From: Stovall - CDPHE, Curtis <curtis.stovall@state.co.us>
Sent: Tuesday, November 28, 2017 5:27 PM
To: Thomas Krasovec
Cc: Dave Folkes; Richard Dean; Dave Stewart, P.E.; MacGregor - CDPHE, Kelly; Walker - CDPHE, David; Ackerman, Joyce
Subject: Re: Additional EM survey
Attachments: 2017-11-28 CDPHE Mark Up of Additional EM Survey Areas.pdf

Further to our earlier discussions and my voice mail this morning, attached is a letter and figures describing the additional EM survey that Stratus plans to perform tomorrow at the Neuhauser Landfill site. The areas depicted for surveying can be adjusted in the field as necessary to ensure we cover all areas of concern to CDPHE. We look forward to seeing you tomorrow.

Document Path: E:\DRH_work\GIS\DE0302_status_redtail_ranch\2017\201711\work\plan_figures\fig2_east_work_area.mxd

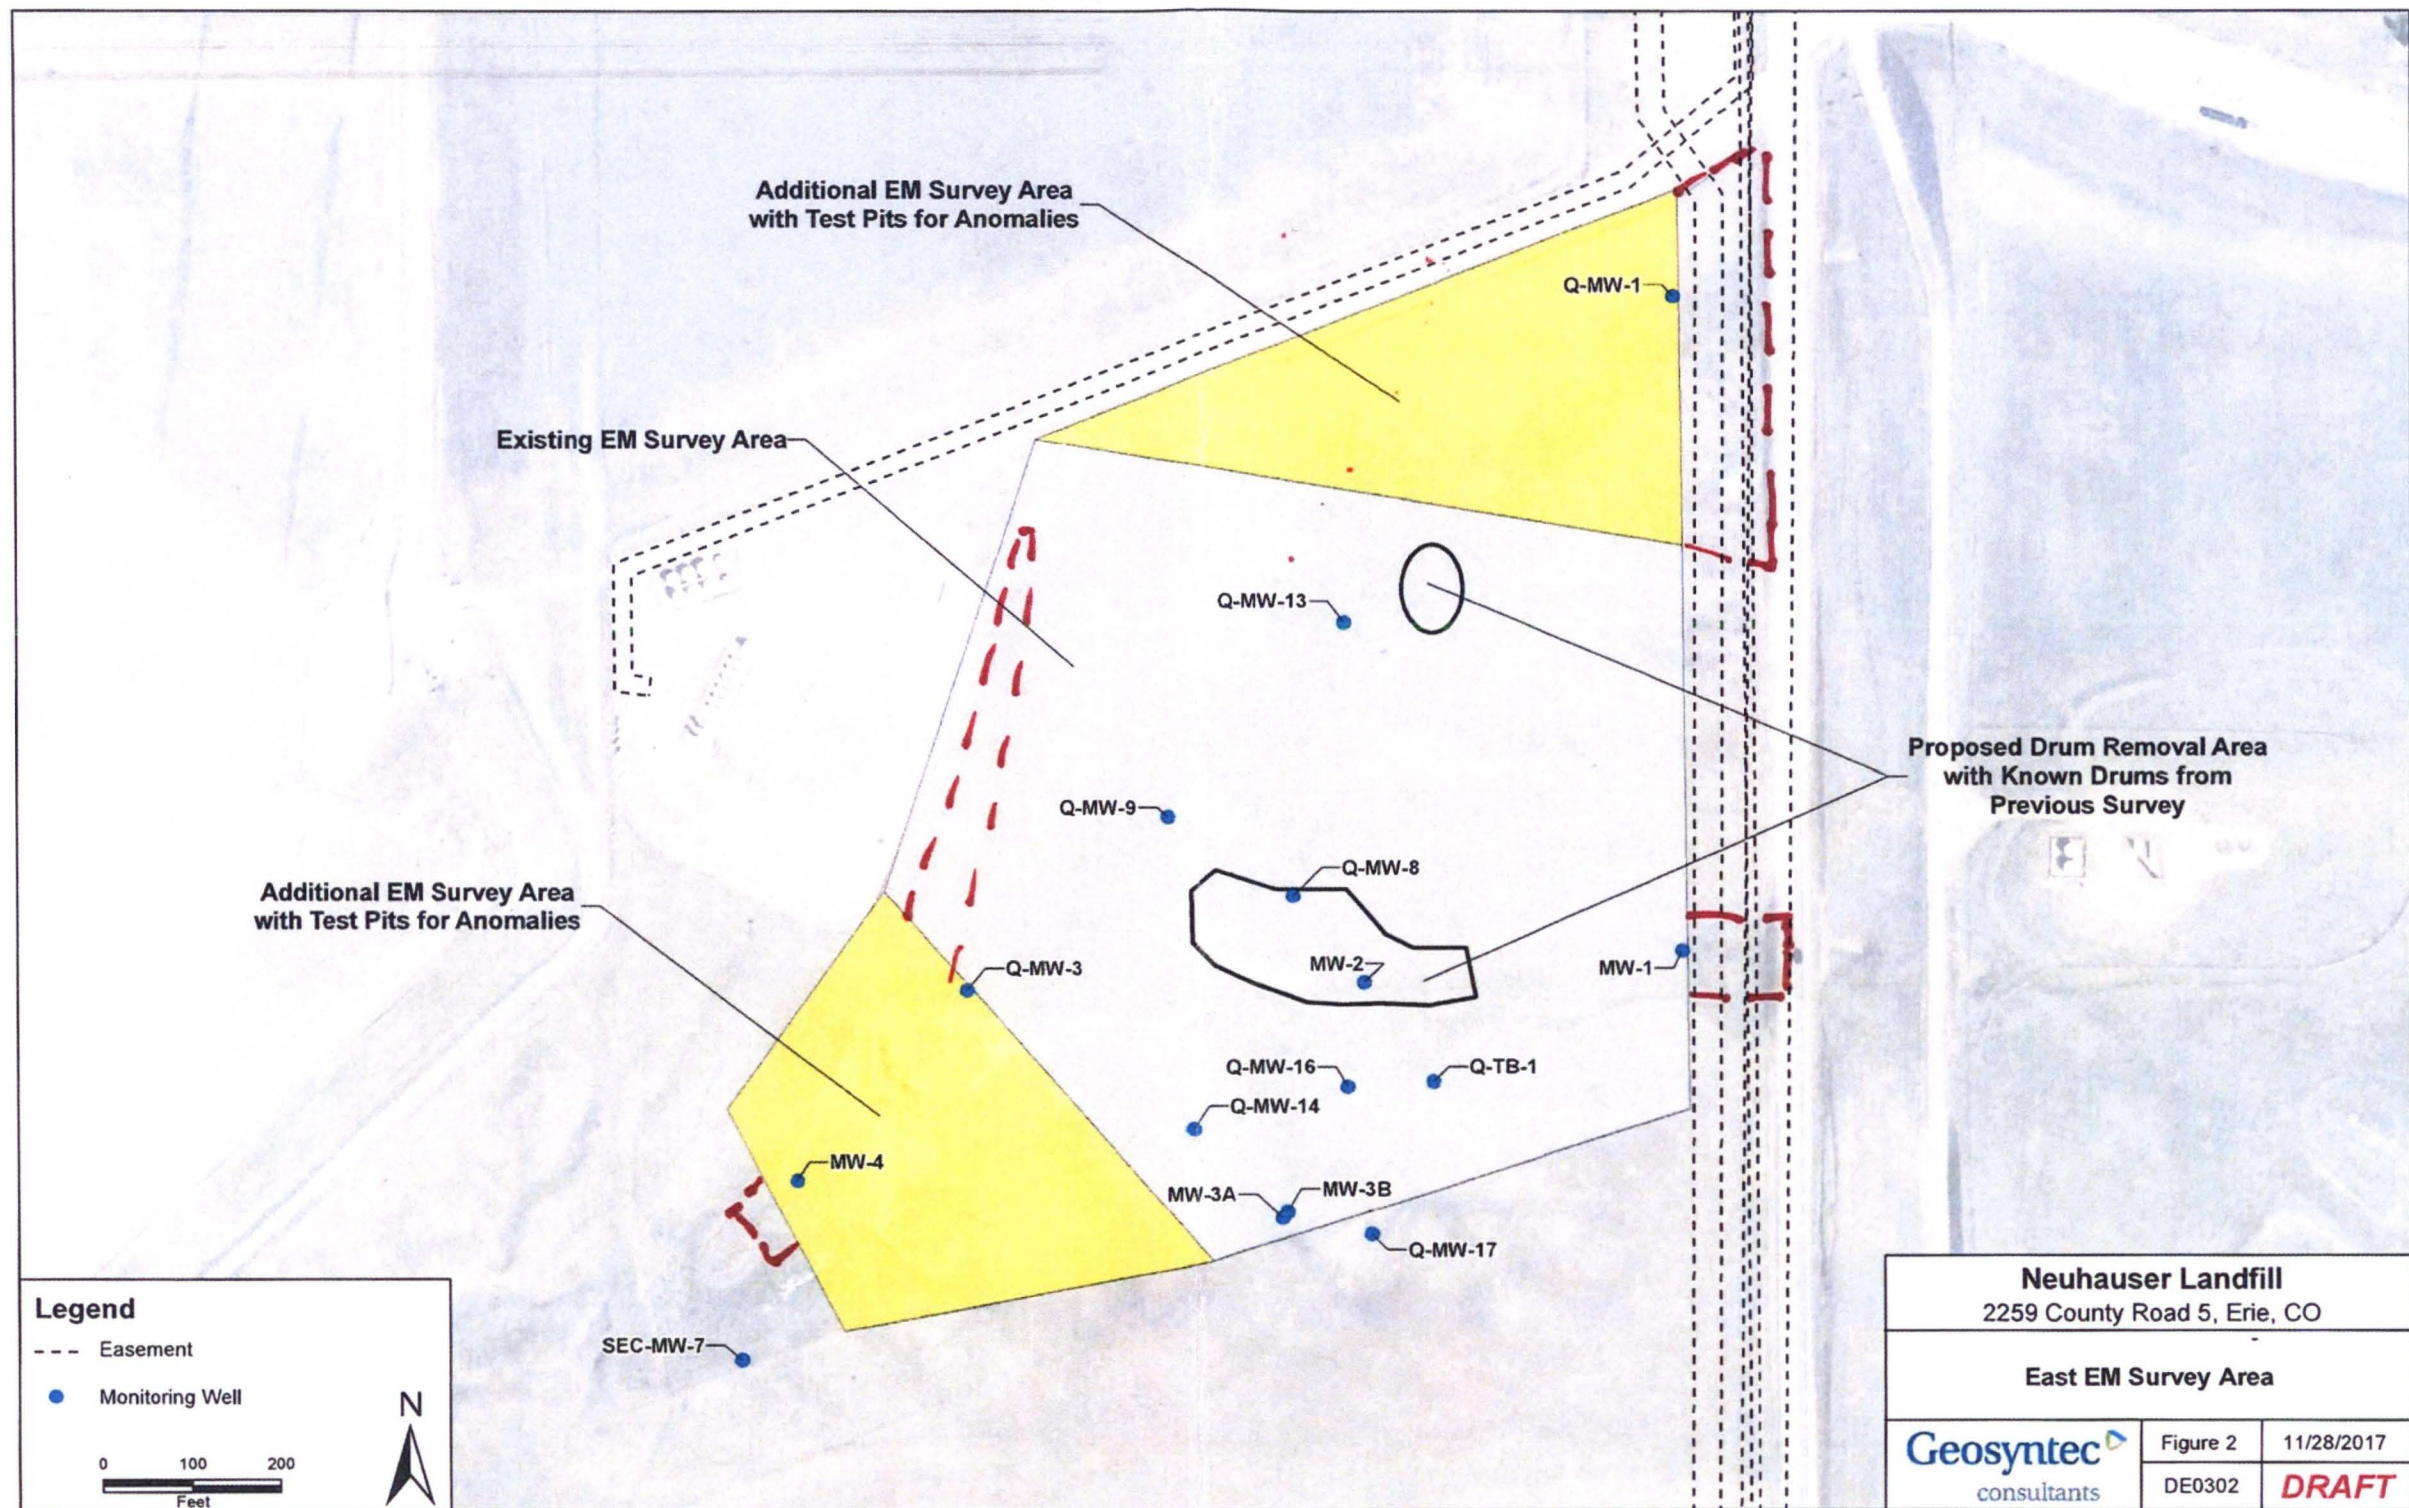
As you requested, I've marked up Figures 2 & 3. Please see the attachment.

We can discuss my mark-ups tomorrow, but I like to explain one of them here. I think your "Existing EM Survey Area" on Figure 2 is a little off, which is why I'm showing the red dashed area inside of the existing EM area. There is a disposal trench in the red dashed area that is on the edge of the existing survey area. It looks to me like only a portion of the trench was surveyed back in July. I'd like to make sure the entire trench gets surveyed this time around.
